CHILDREN'S HOSPITAL
OF ORANGE COUNTY

TOWER II

LEVEL 2
REFLECTED
CEILING PLAN
AREA - B

A4.2B

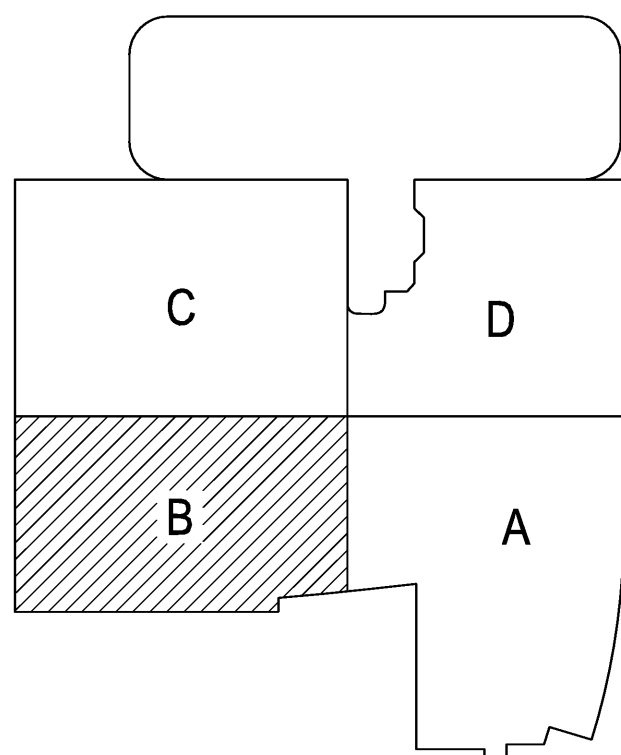
RFI 4708
Install soffit 1'-5"
from mullion. See
for extent of framing
